OLYMPIC DAM PROJECT

**Supplement to the Draft
Environmental Impact Statement**

APRIL 1983

Figure 2.1
**RELATIONSHIP BETWEEN AIR VELOCITY AND
RESPIRABLE DUST CONCENTRATION**

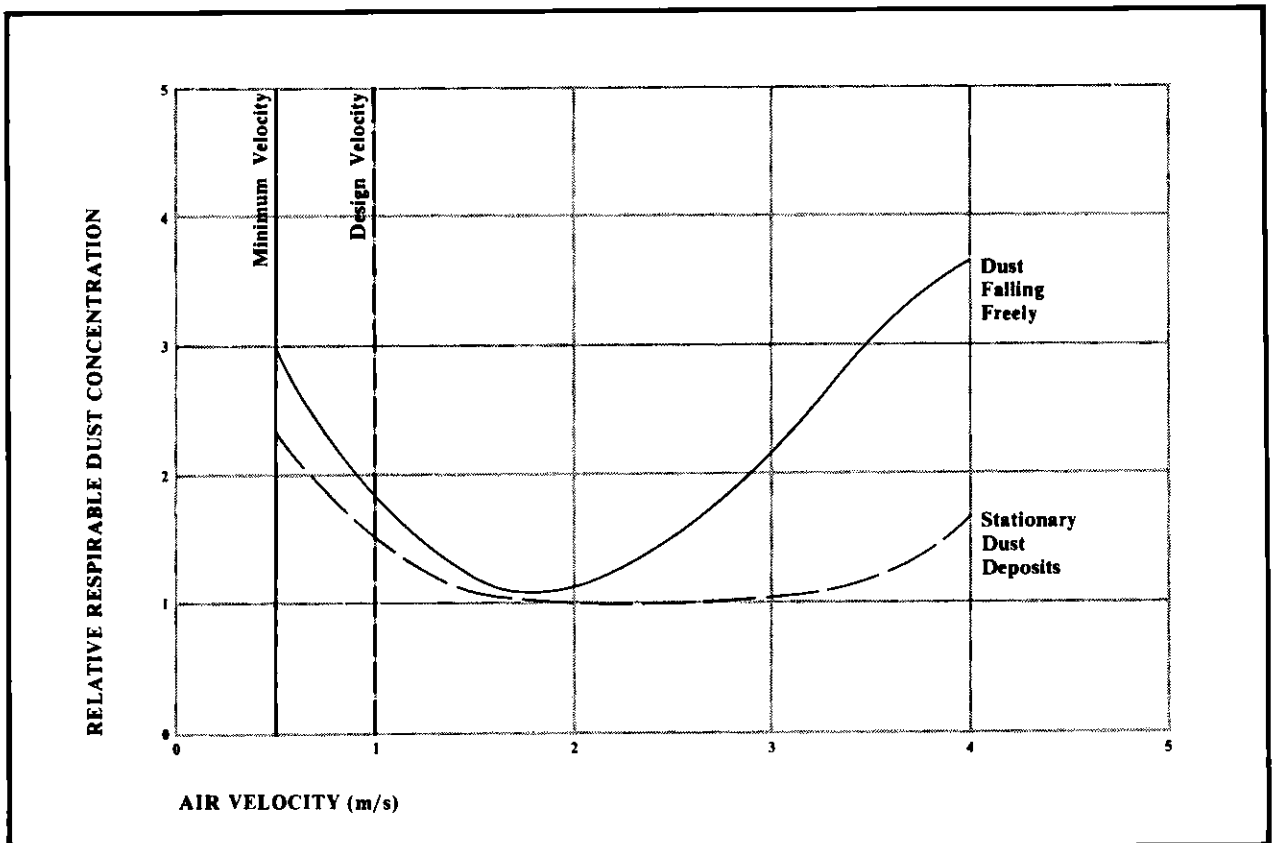
Air Velocity in Relation to Radon Gas Dispersion

The design air velocity for a mine in relation to dust concentration represents a balance between a velocity of sufficient magnitude to disperse dust and a velocity low enough not to resuspend dust. The general relationship between respirable dust concentrations and air velocity is shown in Figure 2.1. Furthermore, air velocity is important in relation to evaporative heat transfer for maintaining satisfactory temperatures in mining areas. The design air velocity in producing areas of 1 m/s (Draft EIS p. 2.12) will ensure adequate dilution and removal of dust, gases, diesel fumes, heat and radon daughters. It is in the optimum velocity (see Figure 2.1) range which provides a balance between dust dispersion and resuspension. The minimum air velocity (0.5 m/s) is still sufficient for control of dust and other air contaminants. Below this velocity the cooling power of the air is significantly reduced.

These velocities compare favourably with the standards of most underground mines. Measurements underground at Olympic Dam confirm that this air velocity is quite sufficient to control the concentration in air of respirable contaminants, including radon daughters, to within limits to which the Joint Venturers are committed and as approved by the statutory authorities. Therefore the Joint Venturers consider the public comment that the air velocity is inadequate to disperse radon to be incorrect.

Figure 3.1
**EFFECT OF PROBABLE MAXIMUM PRECIPITATION
 ON A TAILINGS RETENTION CELL**

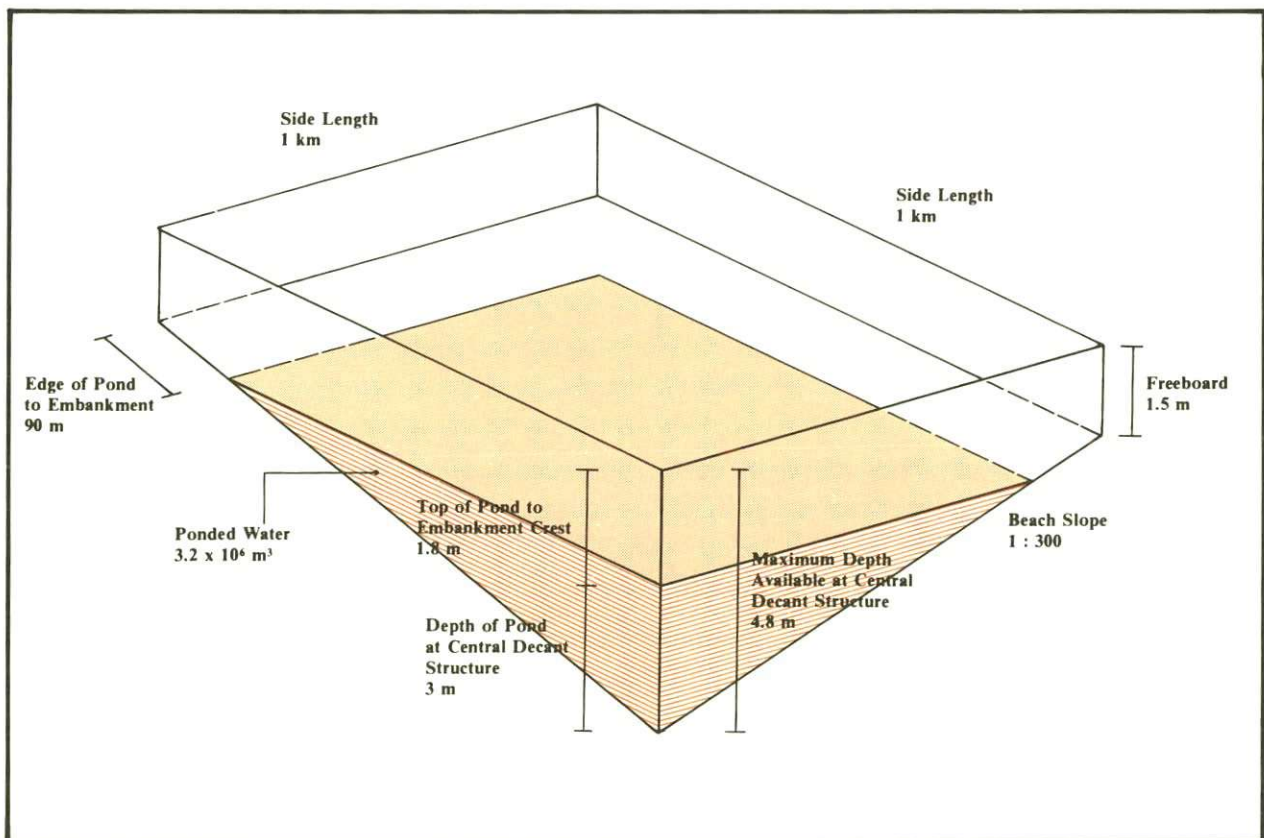
It has been requested that the most extreme storm event which is the probable maximum precipitation (PMP) also be considered. Based upon the generalized method for tropical storms (Kennedy, 1982), the Bureau of Meteorology has estimated the PMP to be 800 mm for a 72 hour storm. It is likely that the generalized method would if anything give conservatively high values. Such rainfall if distributed over a full year would be equivalent to the 1 in 500 year annual rainfall. The total volume of the PMP falling on the 400 ha tailings surface would be $3.2 \times 10^6 \text{ m}^3$. As shown in Figure 3.1, this would create a pond in each cell with a depth at the central decant structure of 3 m and would cover 316 ha of the total TRS area. A minimum freeboard allowance of 1.5 m will be maintained between the crest of the tailings storage embankment and the tailings surface. With the sloping beach, the maximum depth available at the central decant structure would be 4.8 m. At the most critical time where the cells have maximum tailings depth just before the raising of the embankments, there would therefore be a freeboard of 1.8 m for the PMP event. The edge of the ponded water would be approximately 90 m from the embankments, and overtopping would not occur.

The total water storage capacity of the tailings storage with a 1.5 m freeboard is $10.4 \times 10^6 \text{ m}^3$. This volume represents three times the PMP, four times the highest annual rainfall recorded at Roxby Downs homestead over the period 1931-77 and twice the total rainfall for the three wettest years 1973-75 which caused extensive flooding in Central Australia.

Assuming a pan factor of 0.75 (the same as assumed for the decant evaporation pond in Section 7.3.1 of the Draft EIS) and an annual rainfall of 160 mm there will be an annual excess of evaporation over free tailings liquor of approximately 800 mm. This evaporation loss combined with pumping to the decant evaporation pond would return the system to normal after a PMP storm event within a few months.

Figure 5.1
**APPROXIMATE TRAVEL TIME MAP
 FROM OLYMPIC DAM**

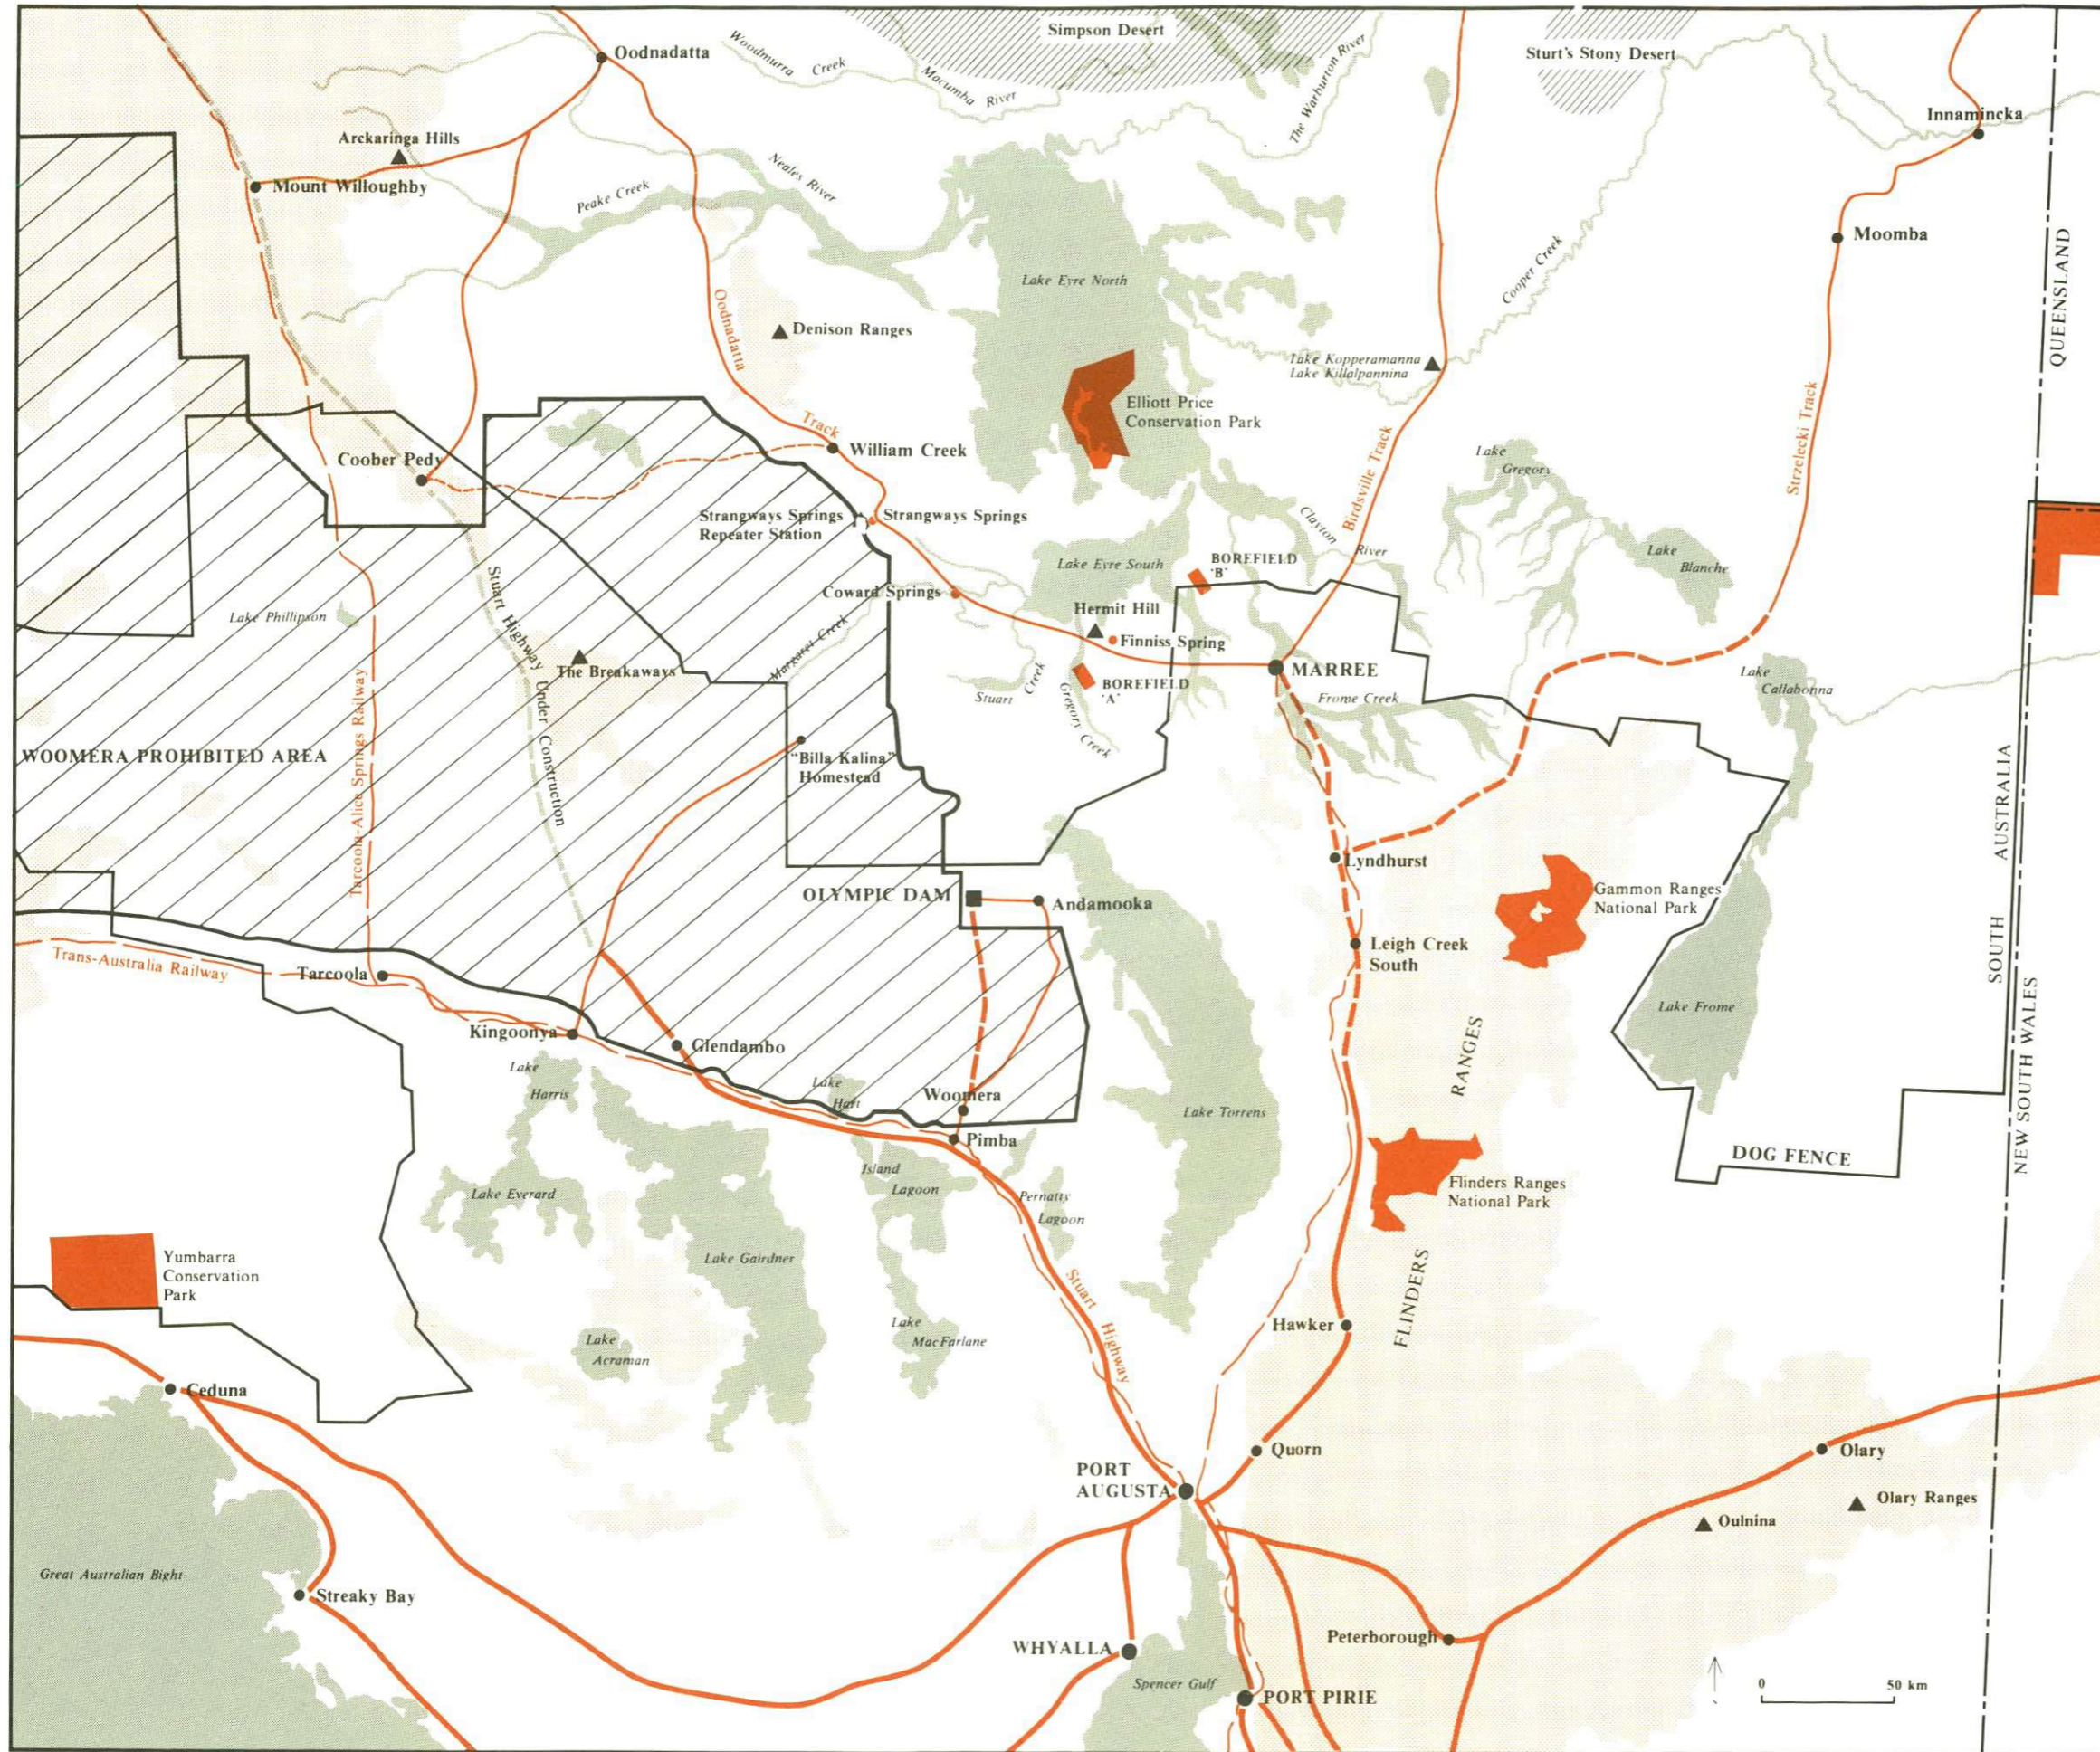
Further Comment

Sites of Environmental Significance: The discussion of the potential indirect impacts in the Draft EIS was not site specific. In order to determine which areas in particular might be involved, an approximate travel time map from Olympic Dam was established (Figure 5.1). Two travel time contours were estimated. One is for a three-hour travel time. Within this contour are areas which can reasonably be visited in a day trip from Olympic Dam. The second contour is for a six-hour travel time. The areas within this contour can be reasonably reached in a two-day (or week-end) trip from Olympic Dam. Location of the travel time contours was estimated from known driving times and advice from the RAA Travel Department that 80 km/h represented a typical average speed for travel on bitumen roads and 40 km/h was appropriate for Far North tracks. Travel times in the Far North are highly variable particularly in relation to weather and road conditions. Thus the contours in Figure 5.1 should be considered approximate.

Figure 7.1
TERRAIN MAPPING IN ENVIRONMENTAL STUDY AREA

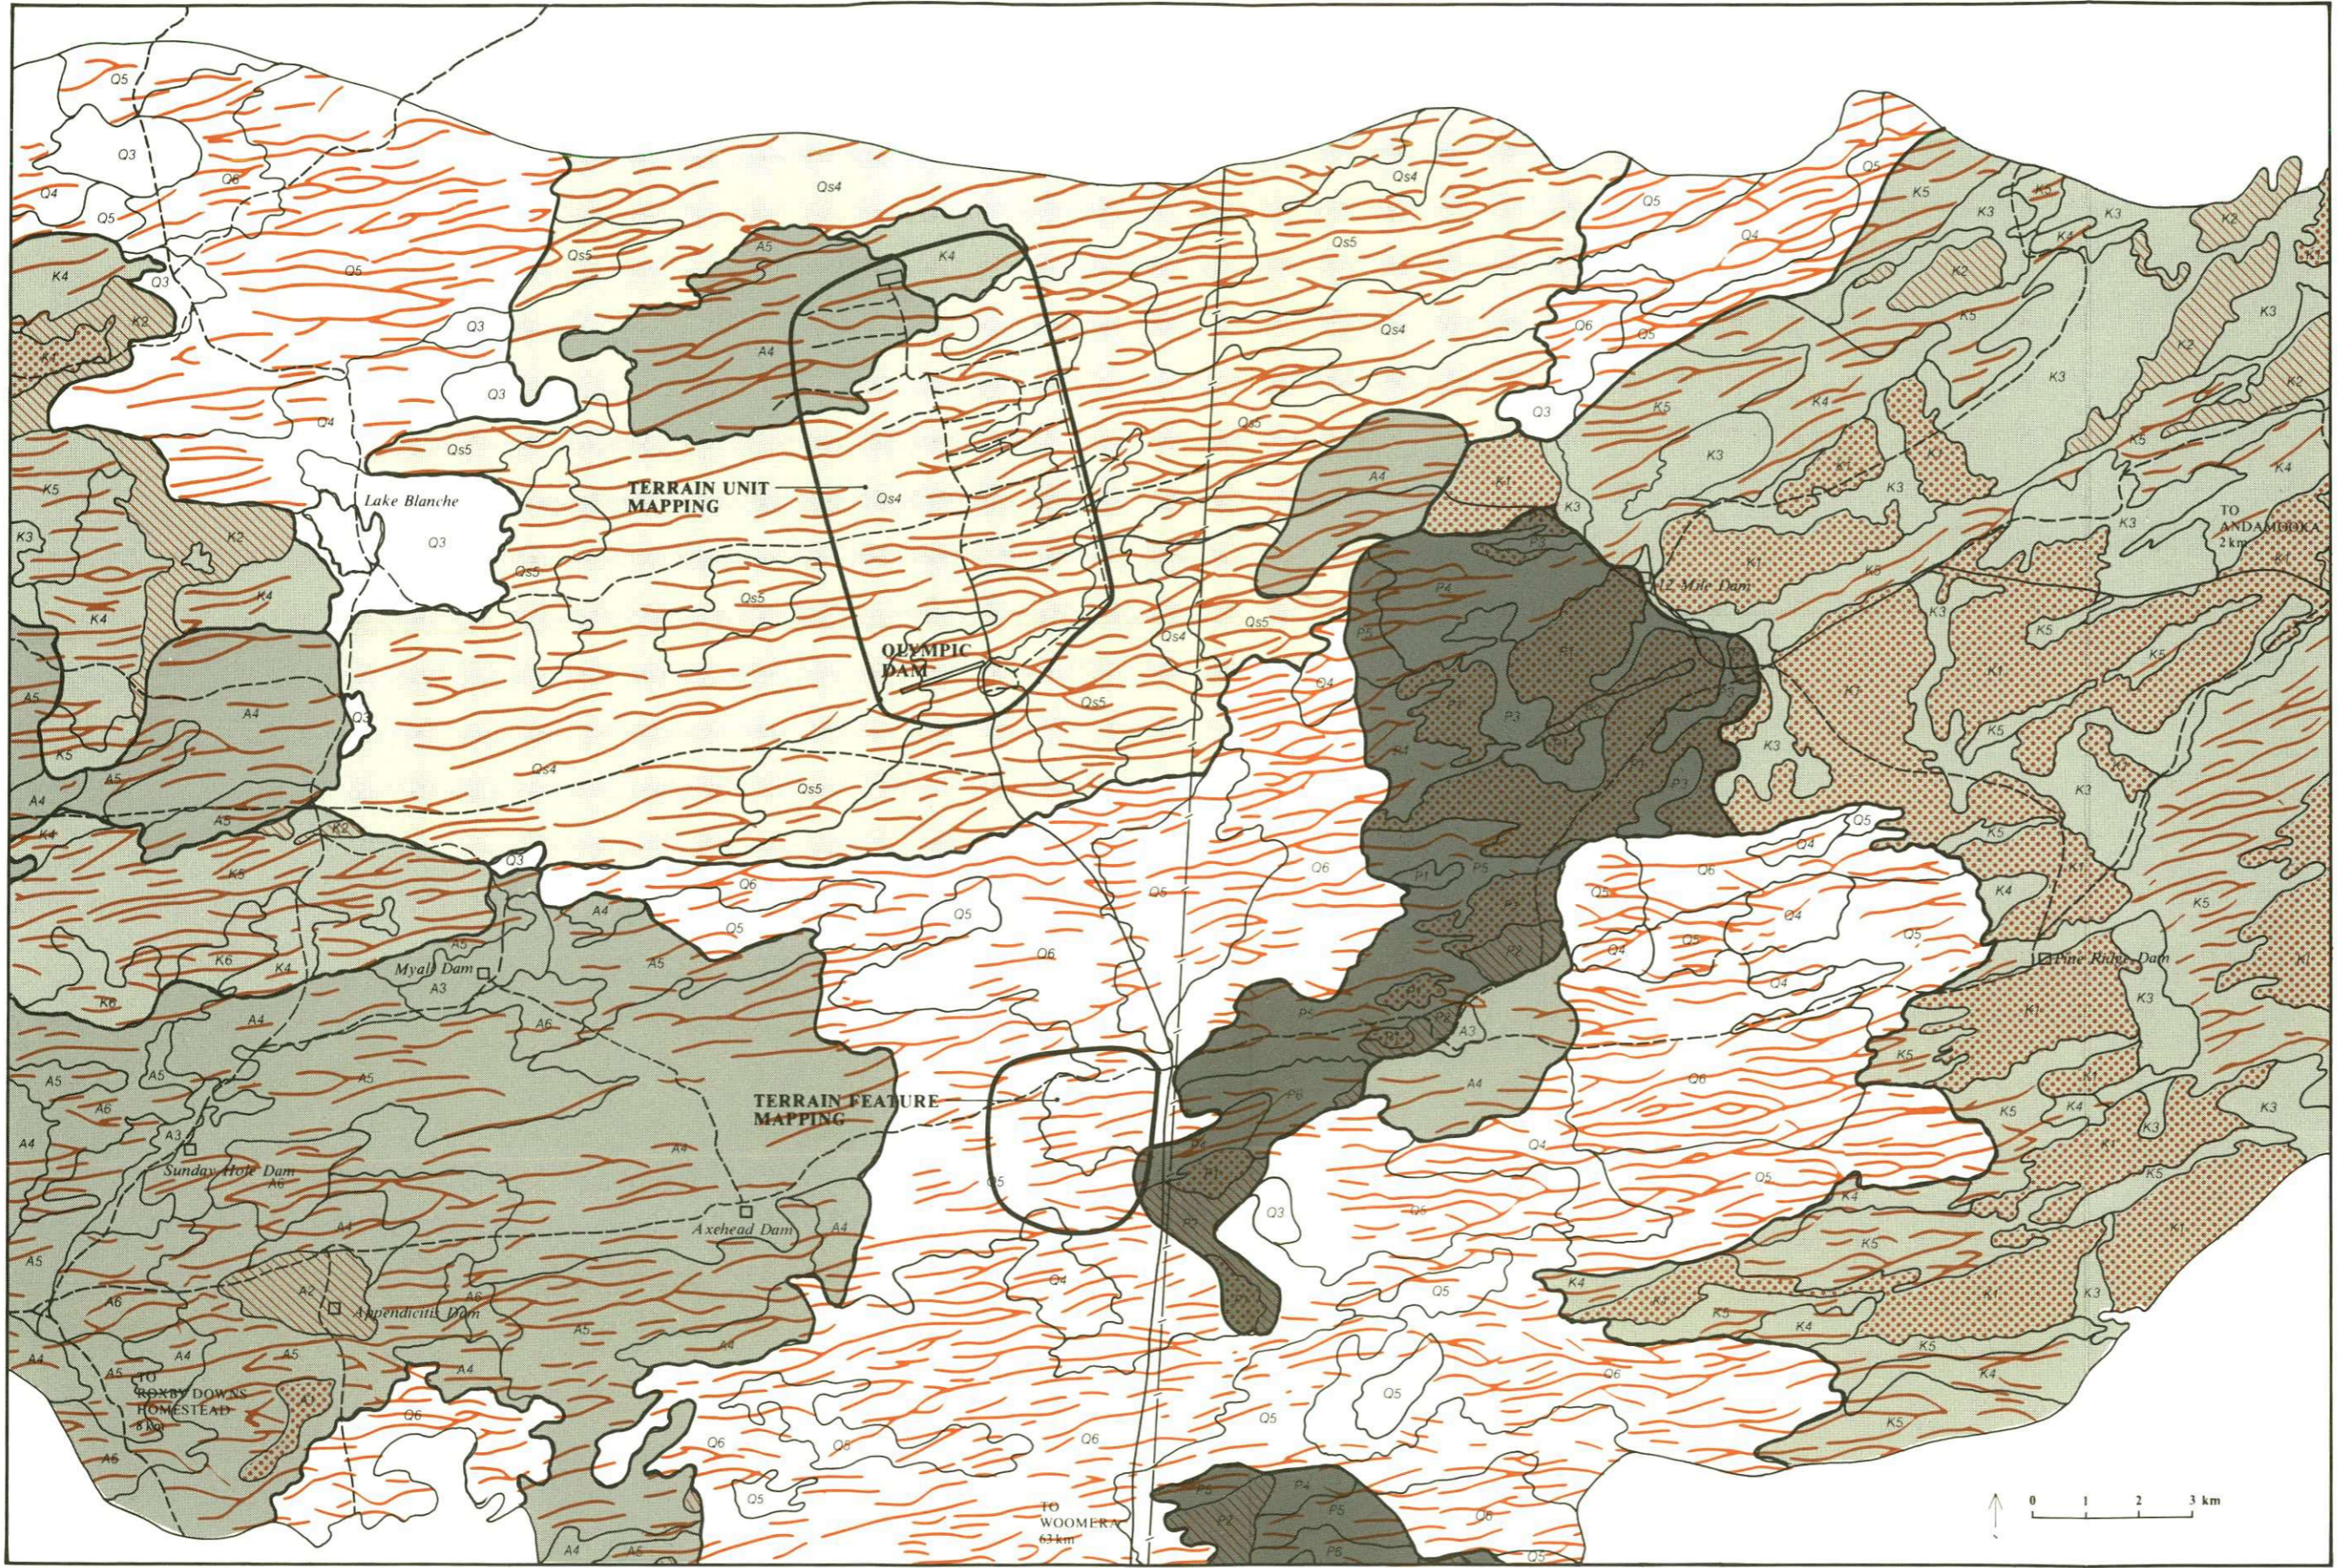
Government also wished to have defined the areas which had been mapped at the various terrain levels. Figure 7.1 shows the coverage of terrain pattern, terrain feature and terrain unit mapping for the environmental study area. The entire study area was mapped at the pattern level, the proposed town site was mapped at the feature level, and the operations area was mapped at the unit level.
